TECHNICAL BULLETIN — October 2015

400. Hydraulic cylinder problems

Issuing Entity:	Bulletin No.: SB-033_01
Vekoma Rides Parts & Services B.V.	Release Date: 19-03-2015
Schaapweg 18	Effective Date: immediately
6063 BA VLODRUP	Supersedes: N.A.
The Netherlands	Completion Date: within 4 weeks fter release of this Bulletin
CoC Number: 12049585

Service Bulletin

Figure 3: information for LE32 and LE25 screw connection at the bottom.

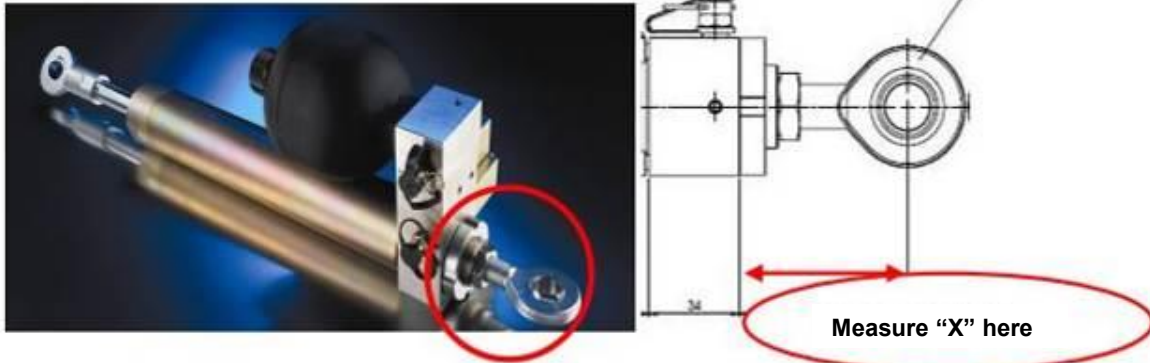
- Issue : The supplier added an additional requirement on the length of the threaded screw assembly. Due to the adjustment function of this connection it is not guaranteed that the threaded screw assembly is within the specified range.
- Action VRP&S' : Checking this connection was included during installation of the HLU in the vehicle.
- VRP&S' advice : Check the length of the threaded screw assembly. If applicable it needs to be corrected. For the correct settings, please refer to the text below for the LE32 units and table 2 for the LE25 units (these values are created from the Supplier's document). Add torque striping to the connection (see figure 2) and perform a weekly check on this area.

The following data apply for all LE32 versions:

For the LE 32 versions the screw thread depth is correct when the rod end length “X” is below 65 mm. ($X < 65\text{mm}$)

The following data apply for all LE25 versions:

For the LE 25 versions the screw thread depth is correct if the rod end length “X” is below the value as stated behind the product number in de table below. The small x at the end of the product number indicates the version number.

We strongly urge you to immediately check the measurement set out above on all Personal Restraint Systems in your possession and advise your technicians to adjust and maintain the measurements specified when installing the unit into a Personal Restraint System or during routine maintenance.

We recommend that the joint rod heads be secured at the specified dimensions and tightened with a torque wrench. The LE 25 version should be tightened to **80 Nm ±10 Nm**. The LE 32 version should be tightened to **90 Nm ±10 Nm**.

The correct measurement must be set and checked when installing or performing maintenance on the Cylinder Accumulator unit. In this way the required minimum screw thread depth engagement (as set out in VDI 2230) is maintained.

This example image is for reference of dimension X only.

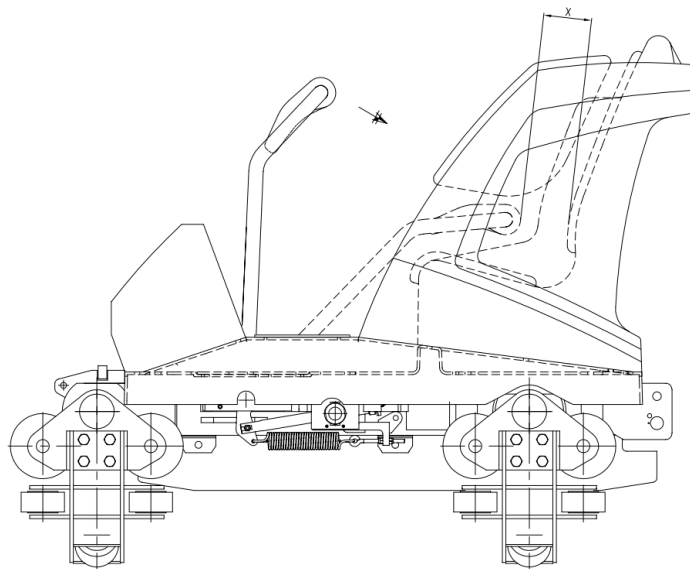
The cycle test is a test which provides information about the functionality of the HLU and the scale of the contaminations. The cycles test has to be performed 1050 times. After completion of 200 cycles succesfully, the ride can be taken into operation with passengers.

Test procedure, **restraint with 2 HLU's**;

1. Close the restraint, make sure the right hand side HLU is only locking the restraint;
2. Measure the minimal distance (X) between the restraint and the seat (only at start of test);
3. Log this dimension for every seat (only at start of the test);
4. Wait for 10 seconds;
5. Measure the minimal distance (X) between the restraint and the seat;
6. In case this dimension increased by 2 cm the HLU failed and needs to be replaced immediately by a HLU which passed the 1050 cycles;
7. If no dimension change was noticed proceed with step 1;
8. Keep repeating this procedure until 200 cycles have passed the test procedure;
9. Repeat this test and make sure the left hand side HLU is only locking the restraint;
10. After completion of the 200 cycle test for the left and the right HLU it is allowed to take the vehicle in operation.

Test procedure, **restraint with 1 HLU**;

1. Close the restraint
2. Measure the minimal distance (X) between the restraint and the seat (only at start of test);
3. Log this dimension for every seat (only at start of the test);
4. Wait for 10 seconds;
5. Measure the minimal distance (X) between the restraint and the seat;
6. In case this dimension increased by 2 cm the HLU failed and needs to be replaced immediately by a HLU which passed the 1050 cycles;
7. If no dimension change was noticed proceed with step 1;
8. Keep repeating this procedure until 200 cycles have passed the test procedure;
9. After completion of the 200 cycle test for the single HLU it is allowed to take the vehicle in operation.
